Manchester, King Street

Planning update

Planning Permission and Listed Building Consent were received (with conditions) on 7th January 2022 for the proposed scheme.

Updates to the design that are required to meet current regulations and standards, and to future-proof the sustainability of the scheme are as listed below.

Amended Elevation B Proposals

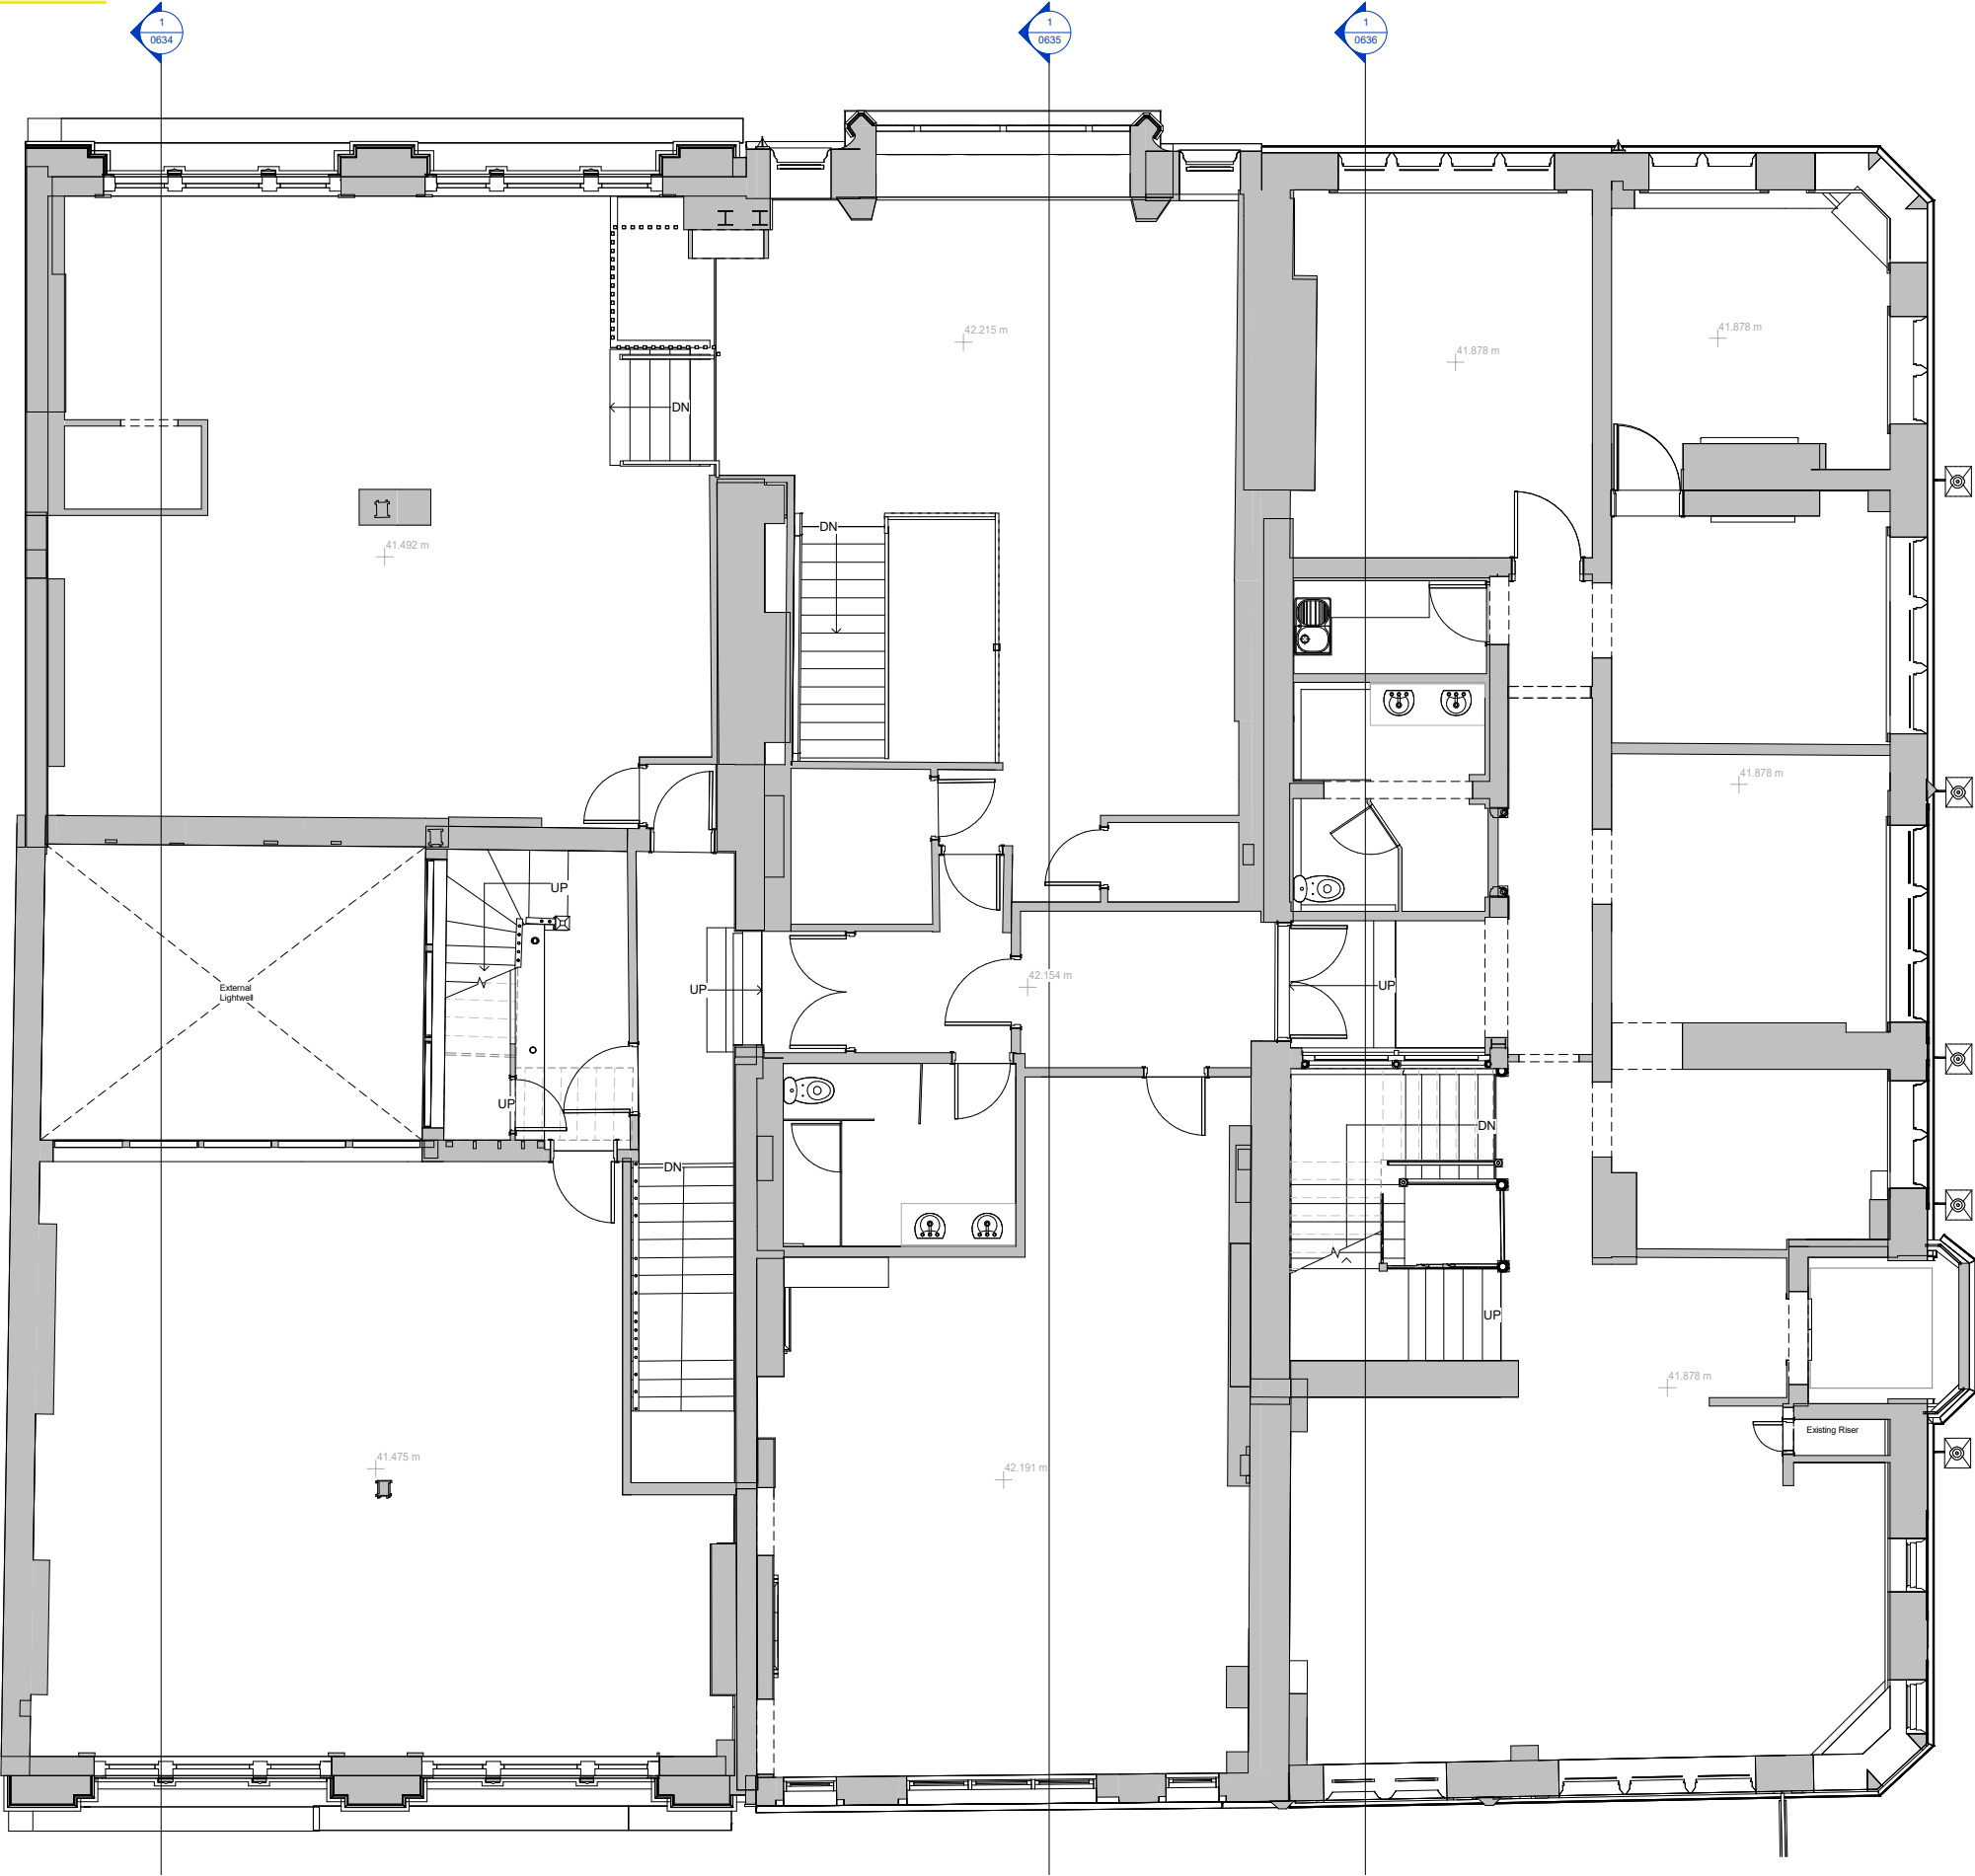
Existing timber windows to be replaced with new aluminium double glazed windows in matching style.

Existing aluminium and PVC windows to be replaced with new aluminium double-glazed windows

Proposed GA First Floor Plan

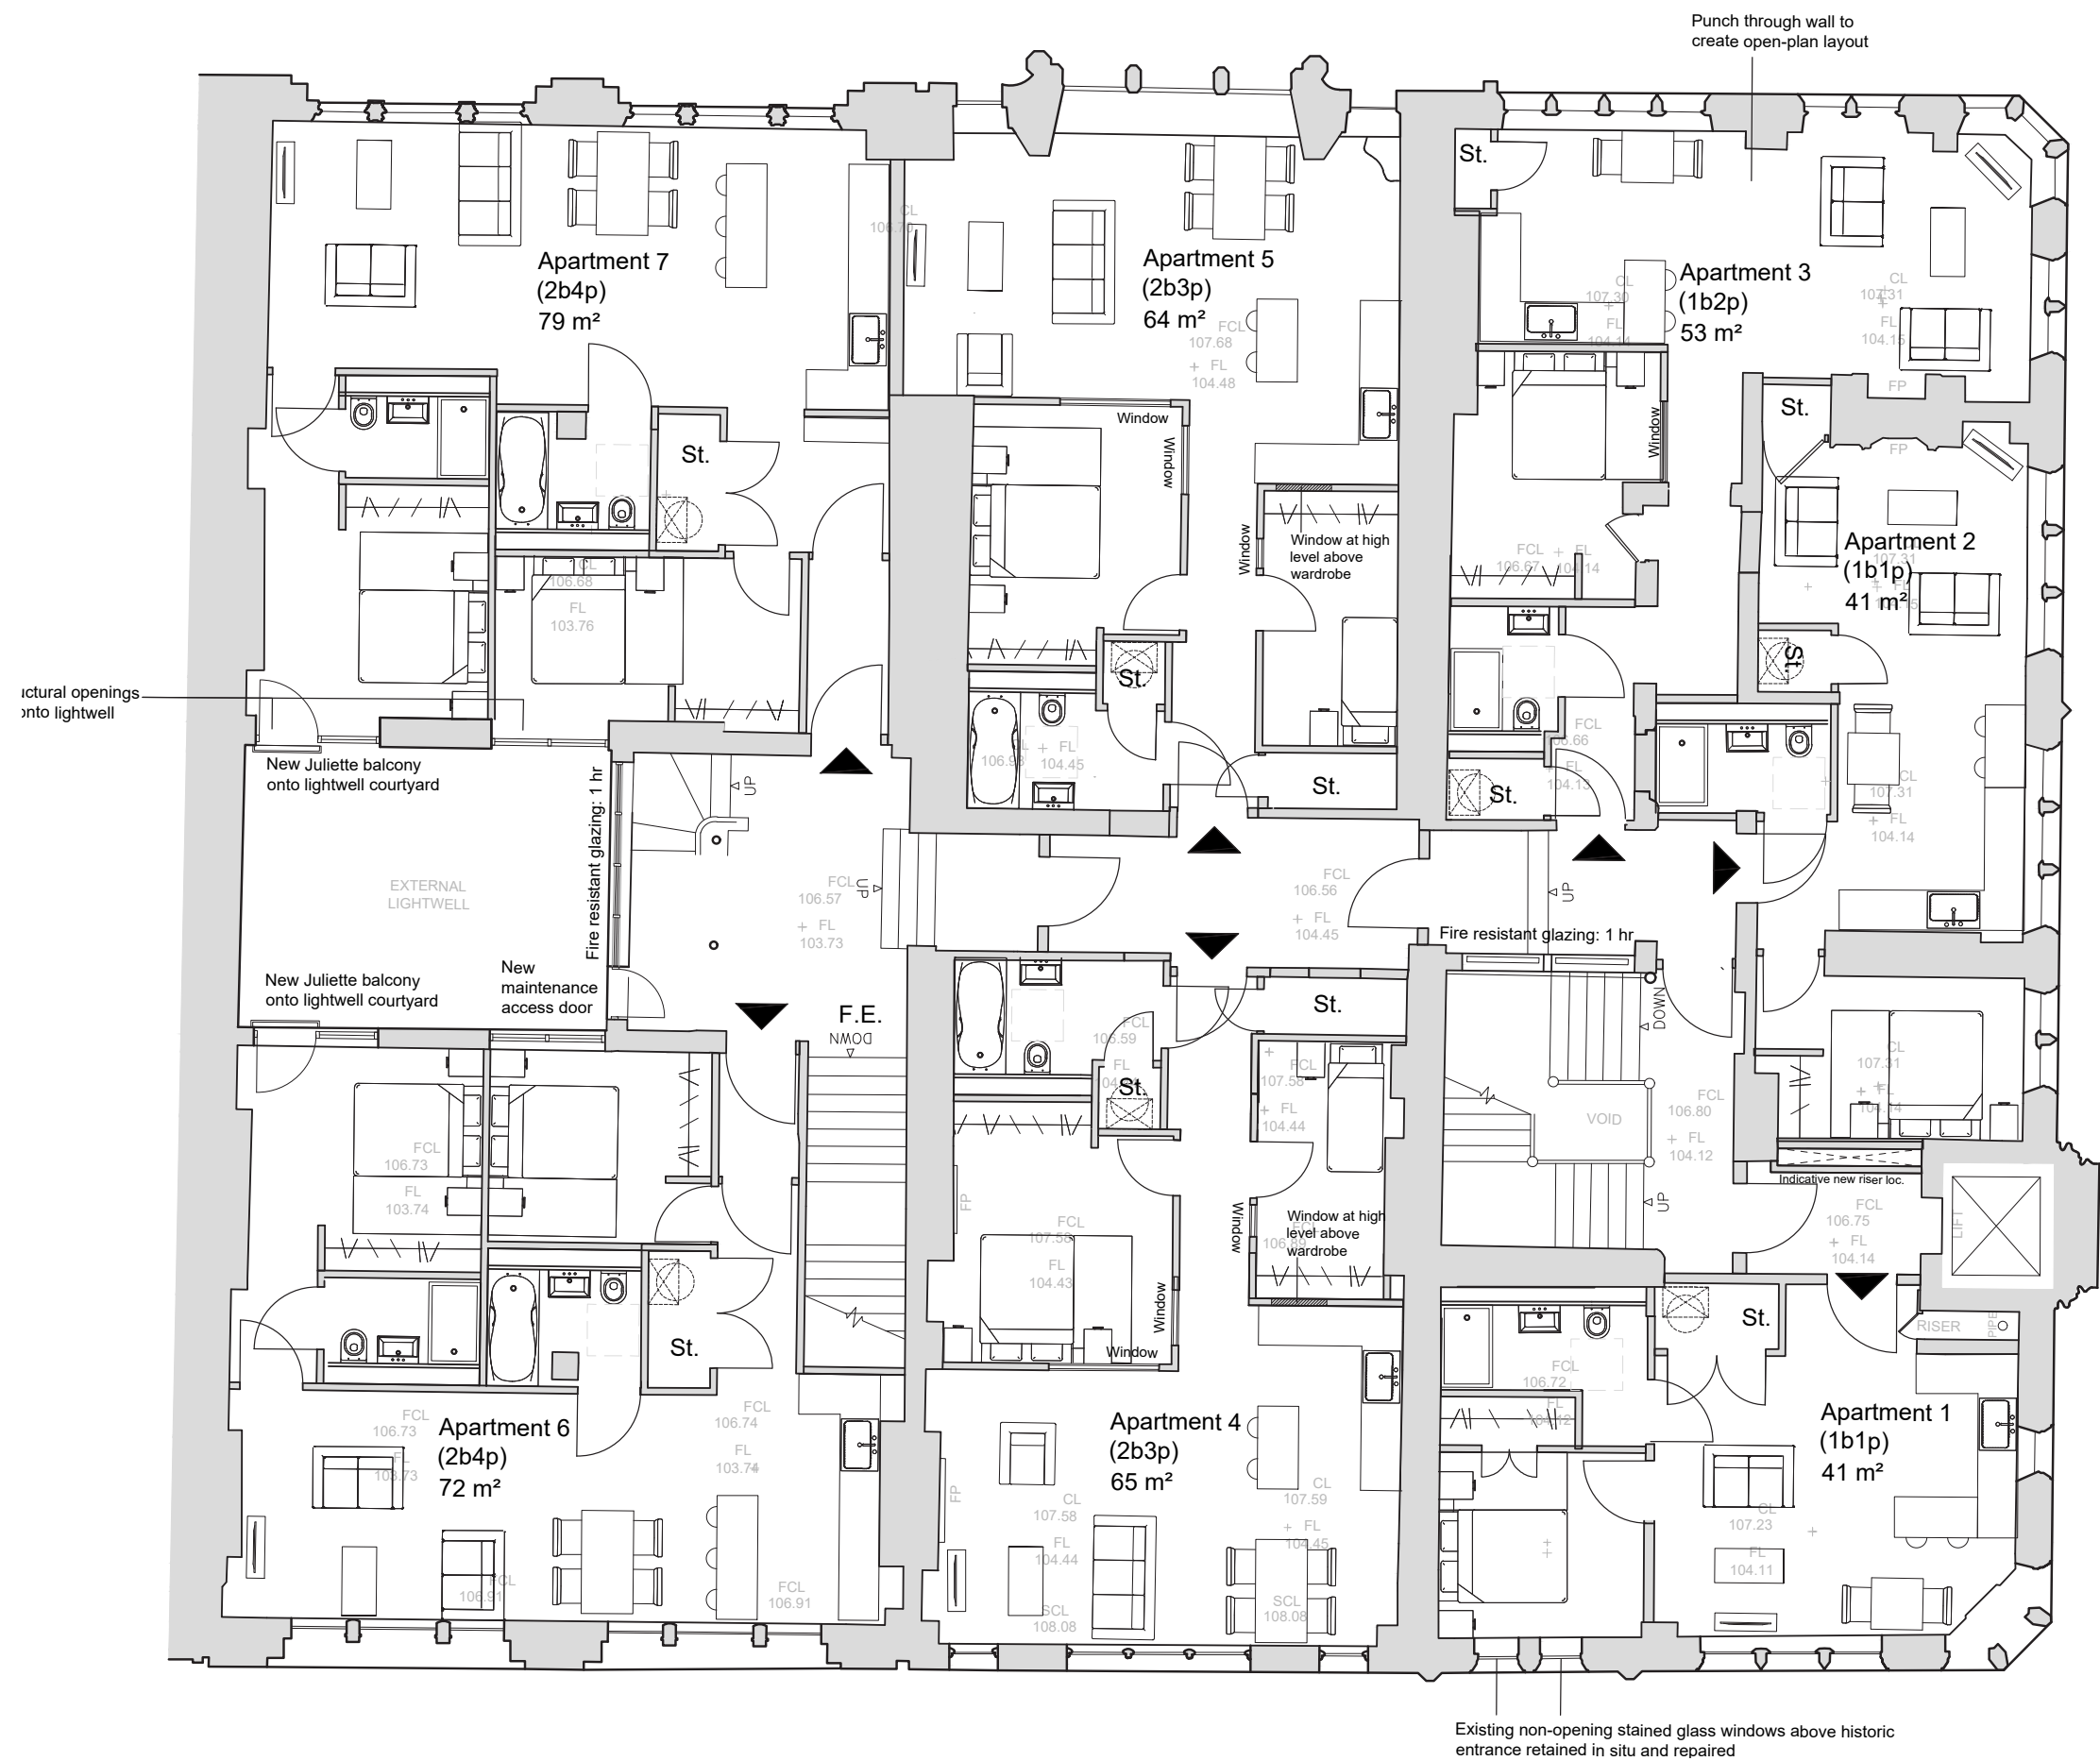
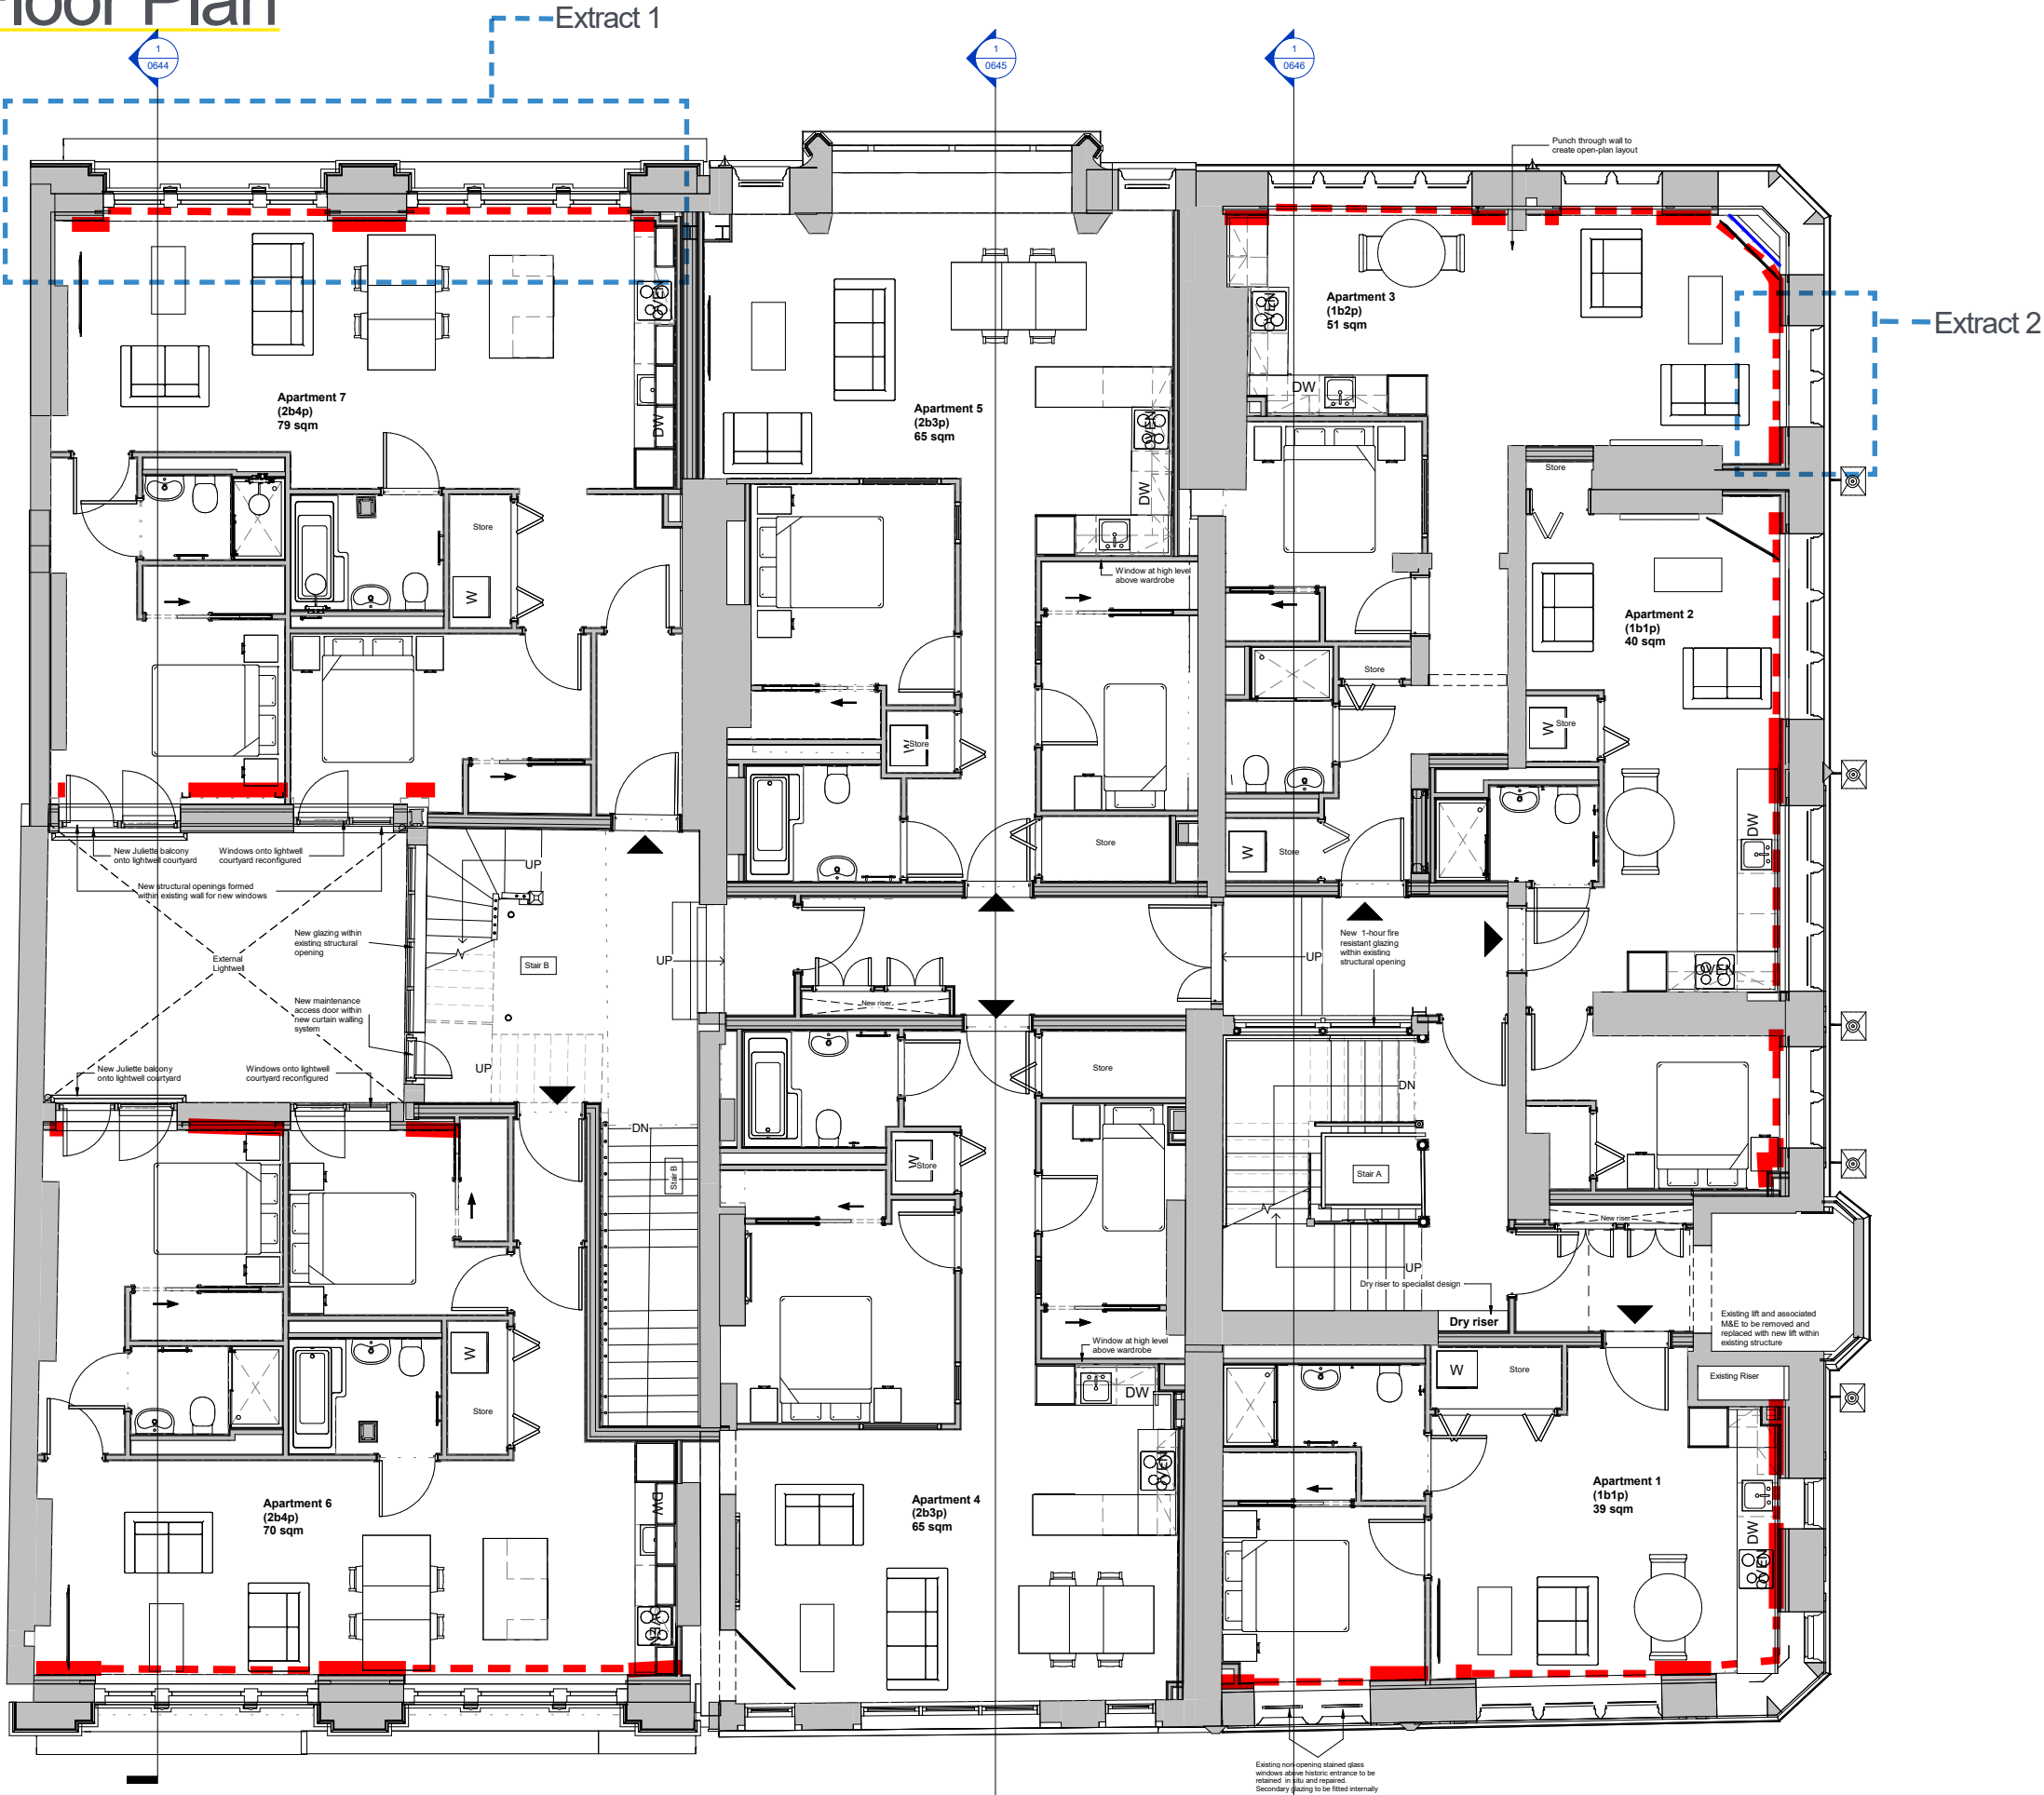
- Internal wall lining to be introduced to external walls of apartments in no 58-60 & 64-66 (non-listed building) for thermal upgrade to achieve EPC C
- Ceiling linings to be introduced to underside of compartment floors to achieve 60 minutes fire resistance and acoustic upgrade
